POWER-UNITS No.53A AND No.53B
 10V 0.25A DC
 SUPPLY FROM 50Hz AC MAINS

N 631
 ISSUE E

N 631
 ISSUE F

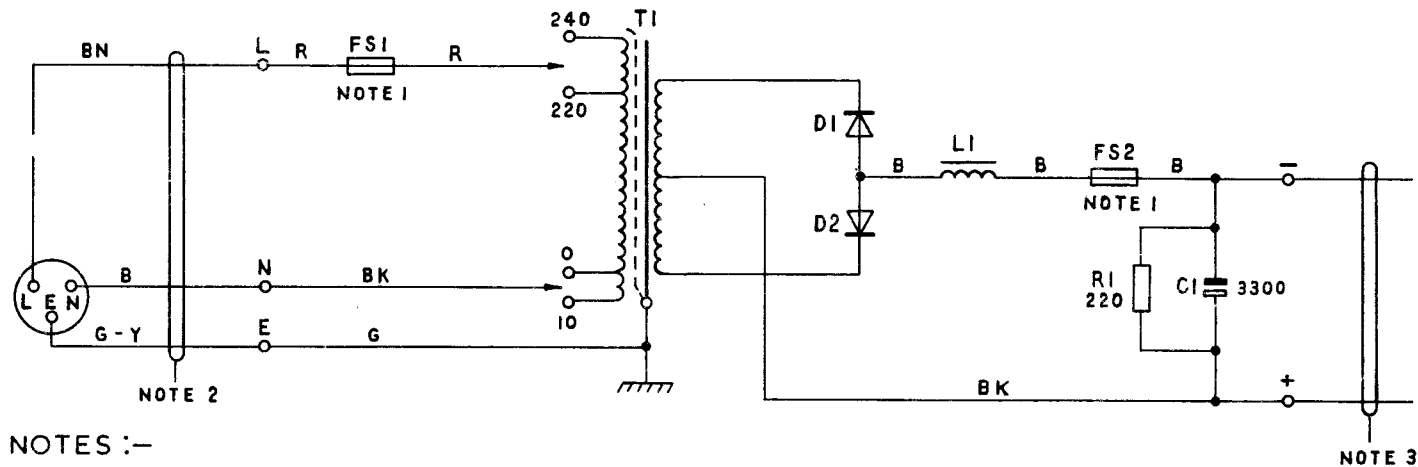
PO TELECOMMS HQRS PAPER :-W DISTN :- GENERAL	E	NEW FORMAT. TRANSFORMER 200V TAPPING REMOVED WIRE COLOURS AND CAPACITOR VALUE CHANGED. NOTES 2&3 AMENDED. NOTE 4 ADDED. 53B INTRODUCED D.L.W. TD 7.2.3	12.4.77
	D	NEW FORMAT KMA	12.7.66

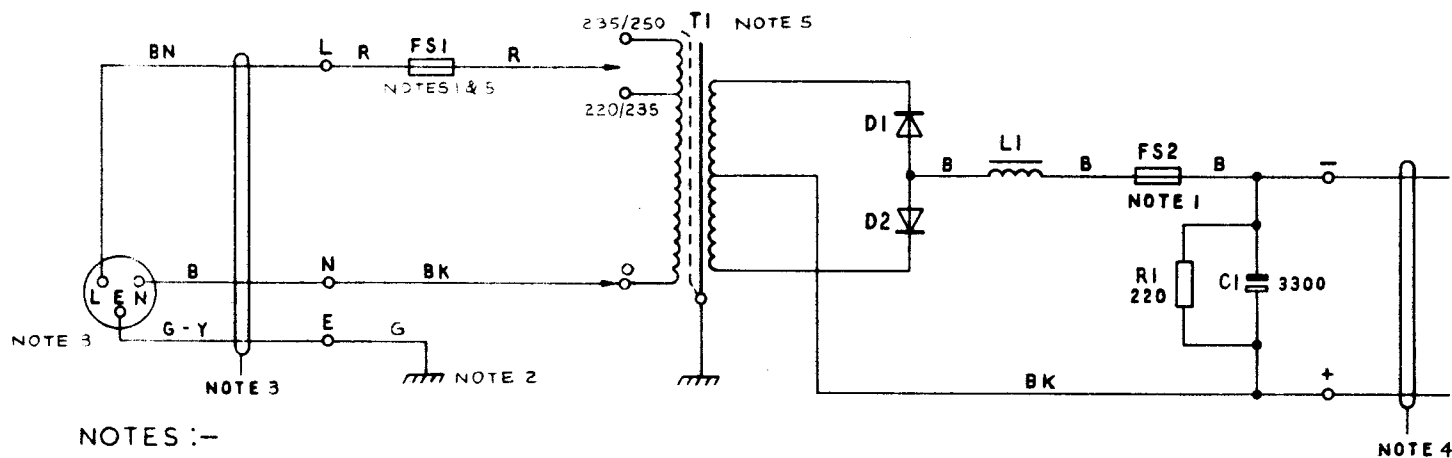
BRITISH TELECOMMS HQRS PAPER :- W DISTN :- GENERAL	W C O D E	F	NOTE 5 ADDED. NOTES 1, 2 & 3 AMENDED. RAS	19-12-83
		E	NEW FORMAT. TRANSFORMER 200V TAPPING REMOVED. WIRE COLOURS AND CAPACITOR VALUE CHANGED. NOTES 2 & 3 AMENDED. NOTE 4 ADDED. 53B INTRODUCED. DLW TD 7.2.3	12-4-77
		D	NEW FORMAT KMA	12-7-66

1. FS1 - FUSE No.80A/0.1 FS2 - FUSE No.36/0.5.
2. THE MAINS PROTECTIVE EARTH MUST BE CONNECTED TO THE EARTH CONNECTING BLOCK OF THE POWER-UNIT. THE OUTPUT MUST NOT BE EARTHED.
3. CORD FLEXIBLE 3183Y 0.75mm² AND PLUG No.103 TO BE REQUISITIONED SEPARATELY AND FITTED LOCALLY. PLUGS TO BE FITTED WITH 3 AMP FUSES.
4. CABLE DISTRIBUTION 3595 REQUISITIONED SEPARATELY AND FITTED LOCALLY.
5. EARLIER VERSIONS OF THE POWER-UNIT MANUFACTURED BEFORE 1983 SHOW DIFFERENT PRIMARY TAPPINGS ON T1. FUSE No.80A/... (FS1) WAS FUSE No.36A/...
